Access Compliance Report Public Rights-of-Way (Curb Ramps)

Main Street: MAYBECK_LN Cross Street: DAWNWOOD Location: NE

ADA ID: RPRK211025115612 Ramp Type: Type 4 - Parallel Initial Pass/Fail: Pass Overall Compliance: No Severity Score: 26

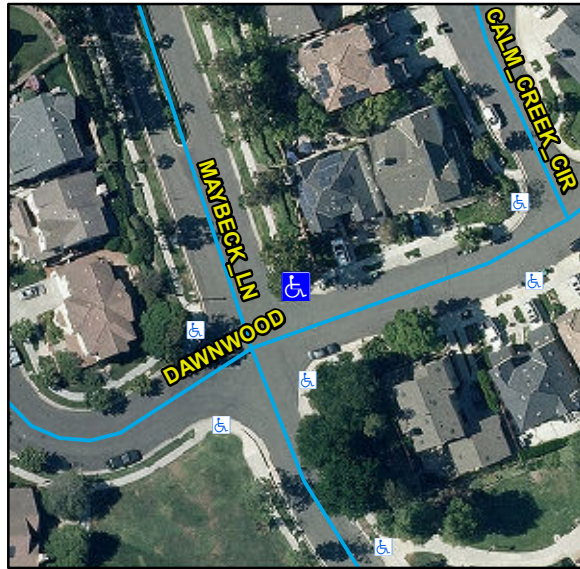
Compliance	Description	Data	Compliance	Description	Data
N/A	Ramp Length LT (in)	106	N/A	Ramp Length RT (in)	107
Yes	Ramp Width LT (in)	60	Yes	Ramp Width RT (in)	58
Yes	Ramp Run Slope LT (%)	2.6	Yes	Ramp Run Slope RT (%)	8.3
No	Ramp Cross Slope LT (%)	3.1	No	Ramp Cross Slope RT (%)	3.2
N/A	Landing Present	No	No	DWS Provided	No
N/A	Landing Length (in)	N/A	N/A	DWS Contrast	N/A
No	Landing Width (in)	N/A	N/A	DWS Length (in)	N/A
No	Landing Run Slope (%)	N/A	N/A	DWS Full Width	N/A
No	Landing Cross Slope (%)	N/A		DWS Offset Type	N/A
N/A	Landing Movement Obstructed?	No	N/A	DWS Offset Left (in)	N/A
	Landing Movement Type	Bush	N/A	DWS Offset Right (in)	N/A
N/A	Landing Shared	N/A			
N/A	Clear Space	Yes			
N/A	Clear Space To Crosswalk (in)	48			
N/A	Marked Crosswalk 1	No	N/A	Marked Crosswalk 2	No
	Crossing 1 Direction	W		Crossing 2 Direction	S
N/A	Marked Crosswalk 1 Width (in)	N/A		Marked Crosswalk 2 Width (in)	N/A
N/A	Ramp Inside Crosswalk 1	N/A	N/A	Ramp Inside Crosswalk 2	N/A

Crossing 1 Slope (%)	1.3		Crossing 2 Slope (%)	4.3
	Crossing 1 Cross Slope (%)	4.1		Crossing 2 Cross Slope (%)	2.9
Yes	Gutter Ponding	No	N/A	Curb Slope	20.9
Yes	Gutter Lip Height (in)	0		Road Run Slope (%)	2.3
No	Gutter Run Slope (%)	11.7		Road Cross Slope (%)	2.3
No	Gutter Cross Slope (%)	3.4	No	Perpendicular Joint Present	No
Yes	Overall Surface Condition	Acceptable			
	Cross Gutter Present?	No		Spandrel Present?	No
	Replace Cross Gutter?	N/A		Replace Spandrel?	N/A

Remove & Replace Curb Ramp With Two New Directional Ramps or Equivalent. Remove & Replace Gutter.
